To: Lindsay McGavin
From: Denise Galle
Subject: Development Application DA09/0635.07 - amendment to development consent DA09/0635 warehouse with partial demolition of existing factory and retention of offices and amenities at Lot 2 DP 619871, No. 35-37 Morton Street Chinderah
Reference: DA09/0635.07

S96 Modification Assessment Report

Section 96 Application DA09/0635.07 - amendment to development consent DA09/0635 warehouse with partial demolition of existing factory and retention of offices and amenities at Lot 2 DP 619871 No. 35-37 Morton Street Chinderah

1295 WD40.I D

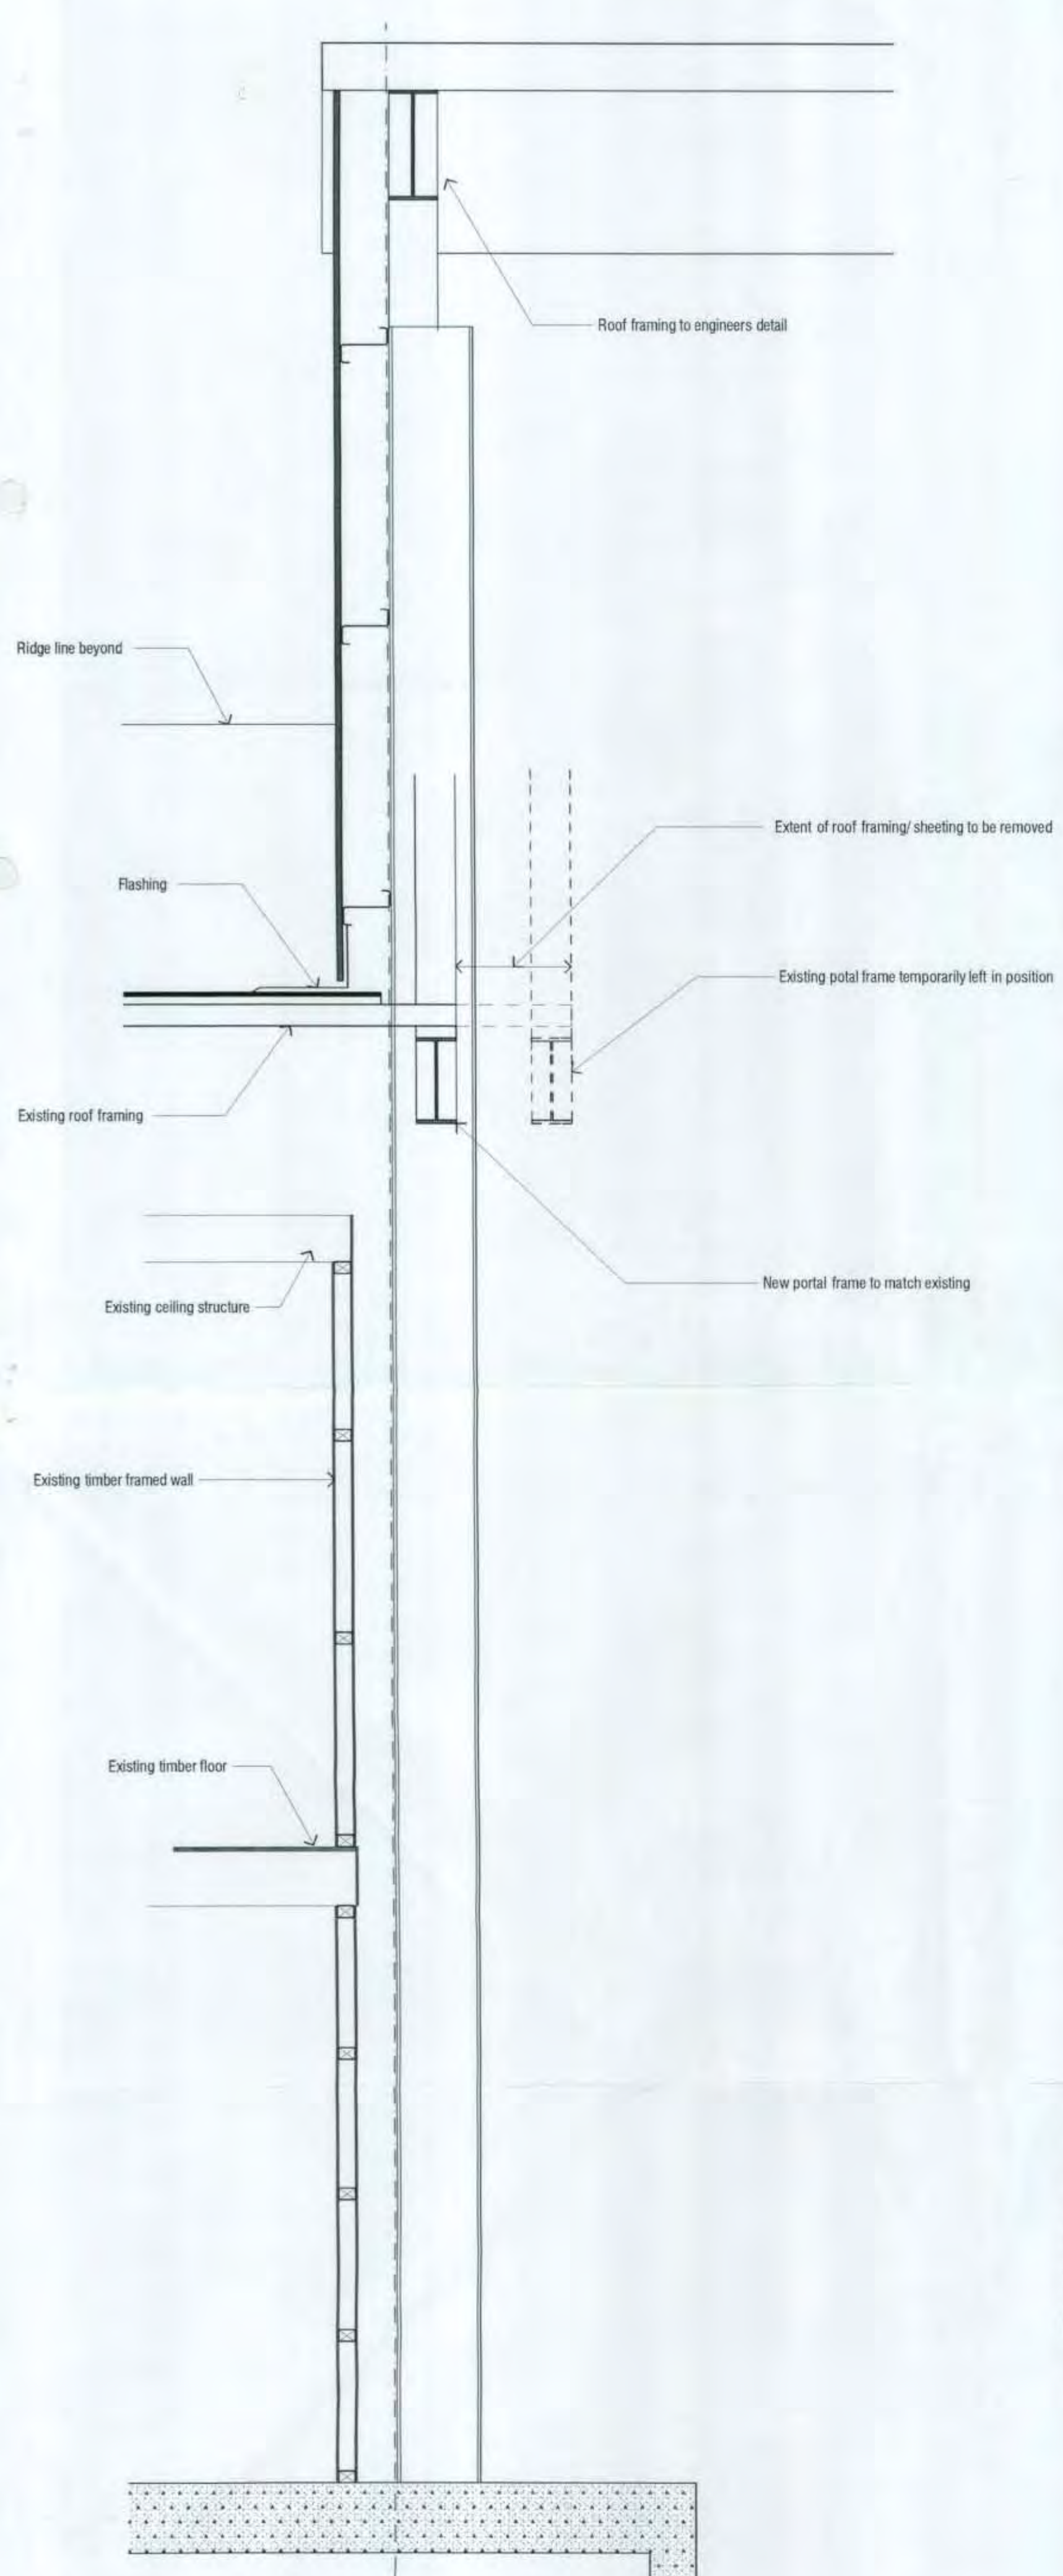
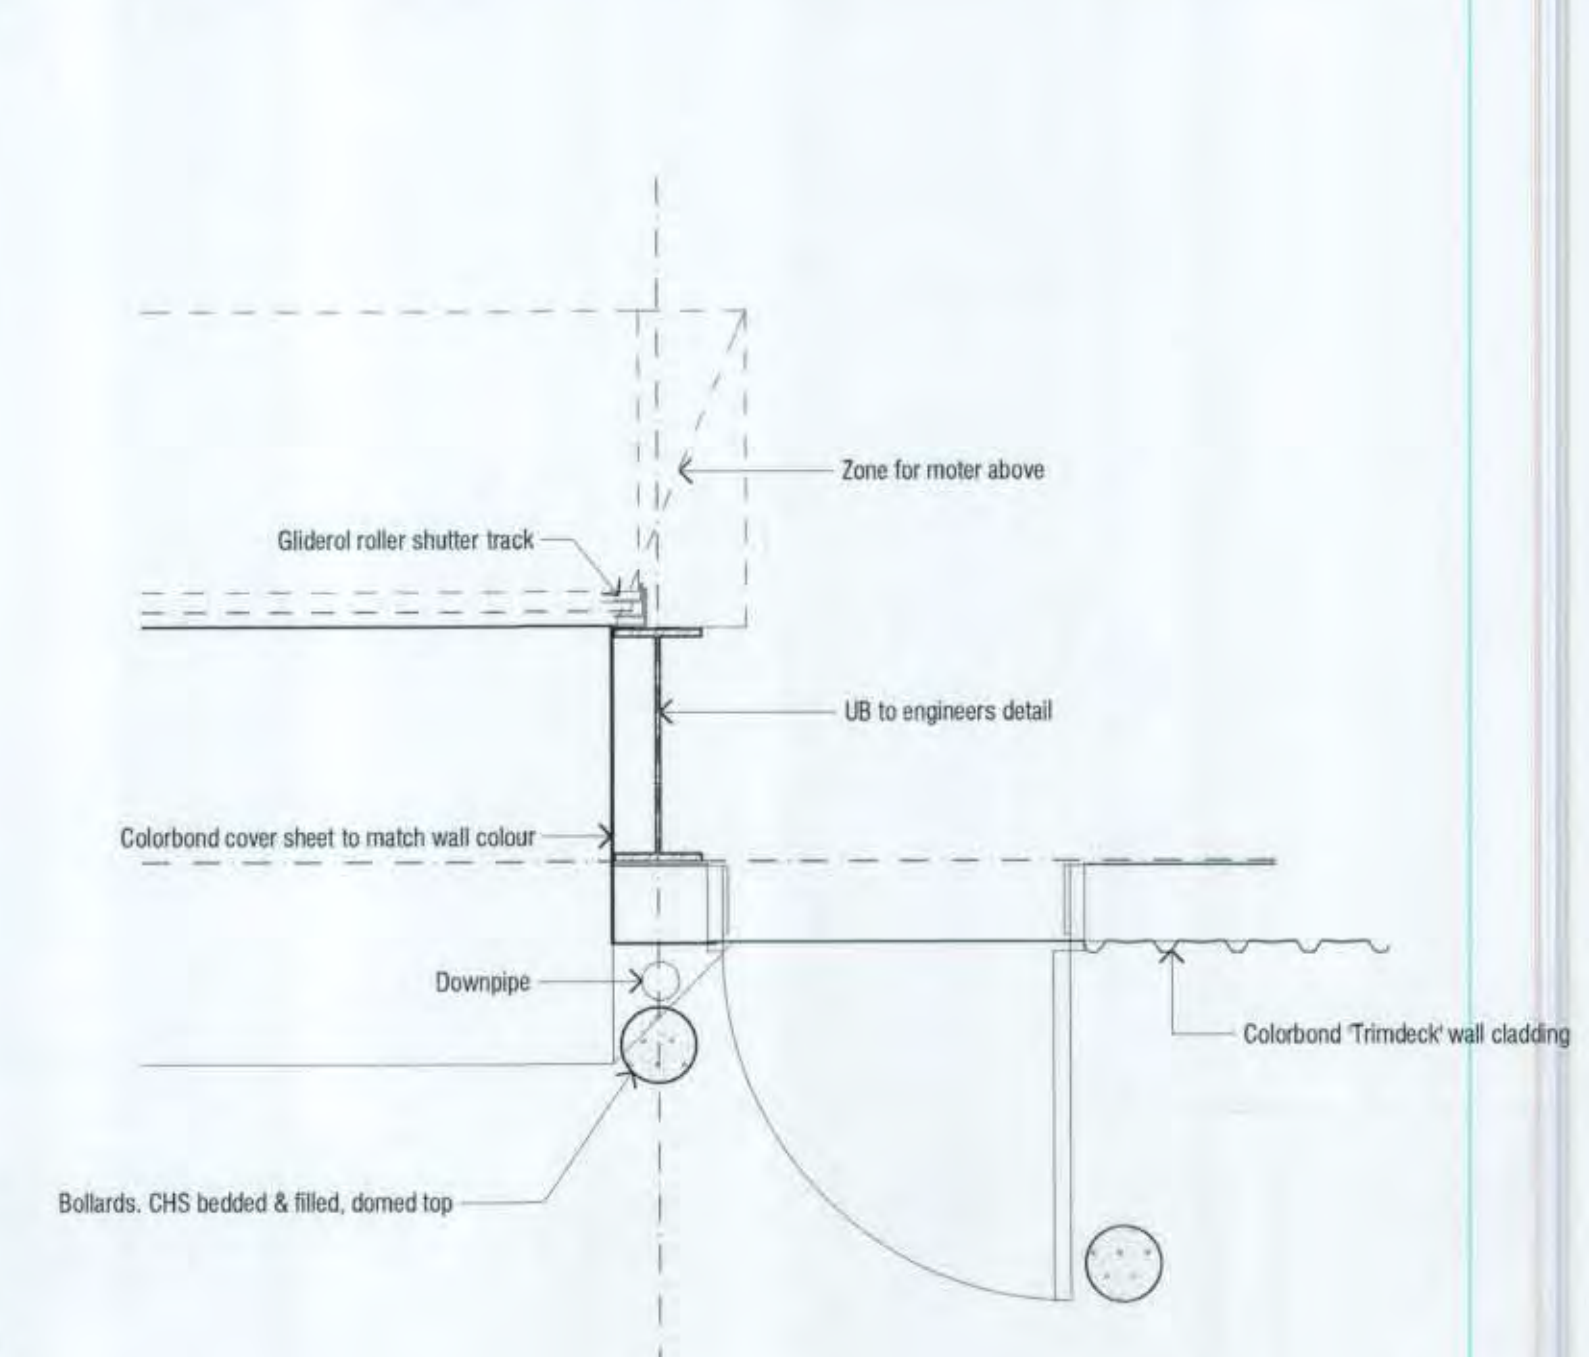
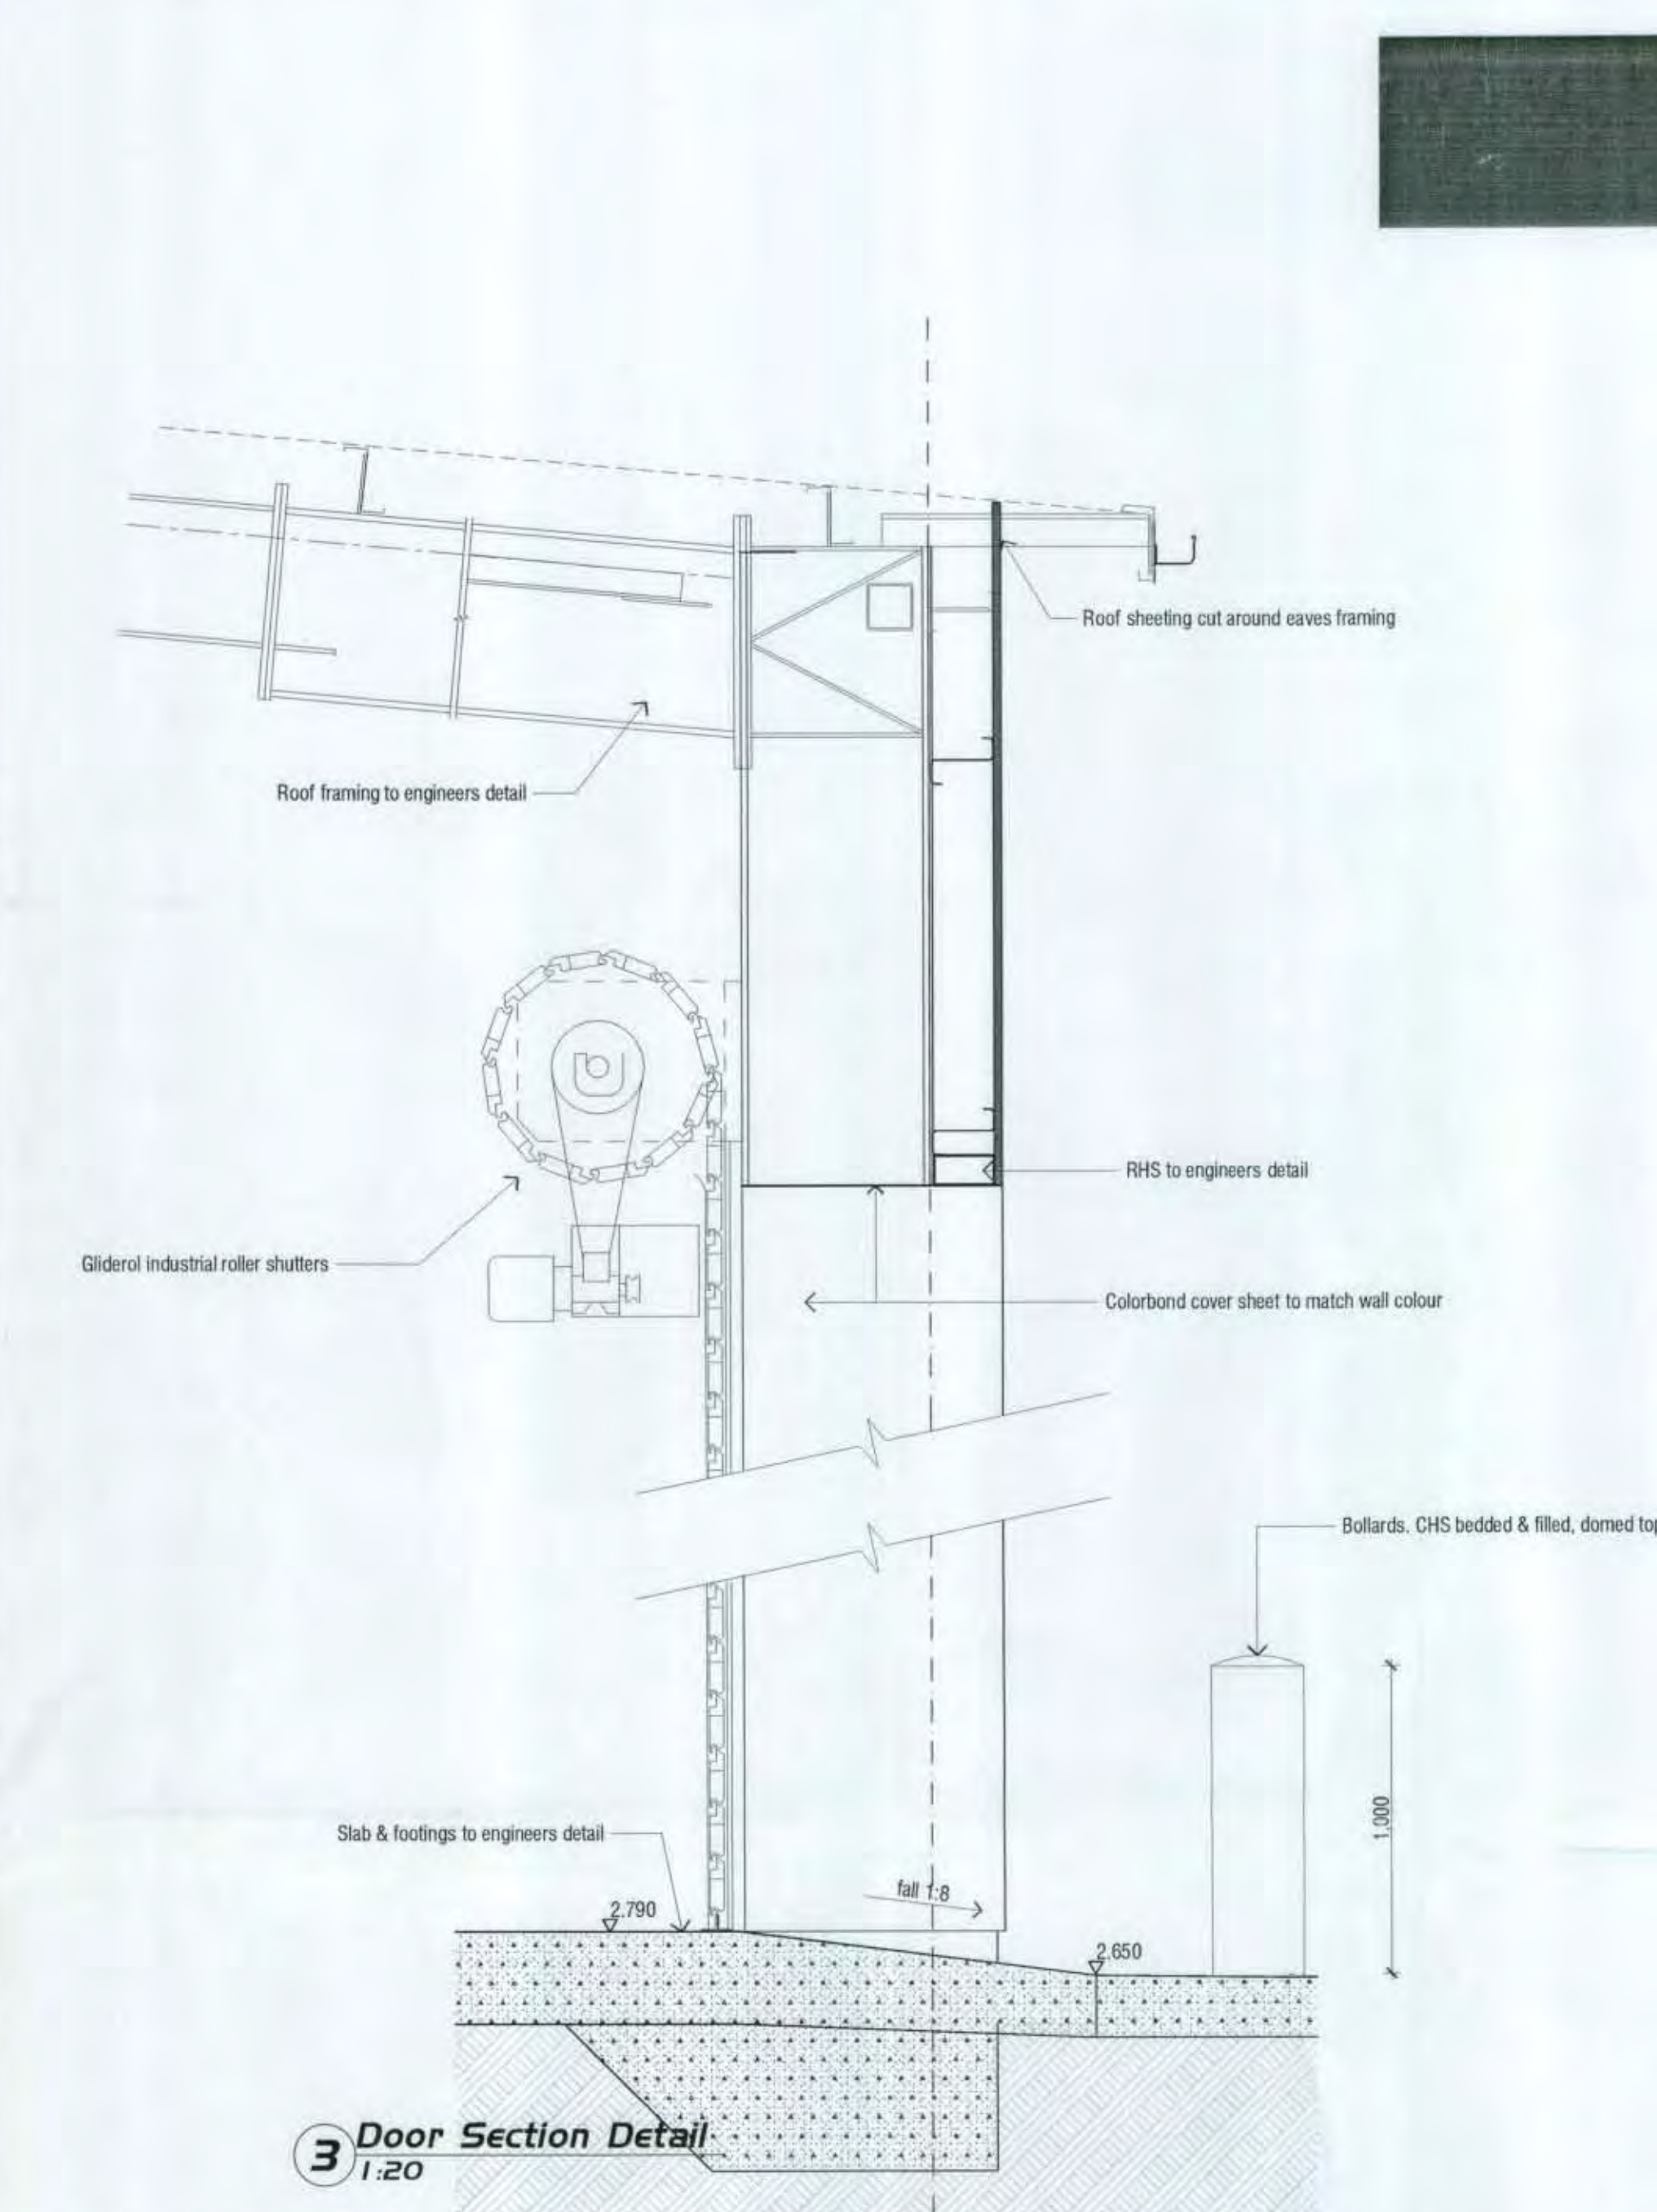
1. *Two (2) internal pits of 1.2m depth;*
2. *The provision of a transformer and pad adjacent to the Morton Street frontage;*
3. *The installation of a weighbridge between the building and western property boundary including a third pit of 1m deep;*
4. *Realignment of plan Grid A 500mm towards the northern boundary with corresponding 500mm reduction between Grid A & B (note overall building length and setbacks have not altered);*
5. *Minor amendment the to north elevation, through the relocation of small 1.2m by 1.2m precast opening (refer highlighted area on drawing WD20.1)*

- 1295-WD40.1 Issue D – Details (weighbridge), prepared by Lightwave Architecture and dated 18 May 2010,
- except where varied by the conditions of this consent.
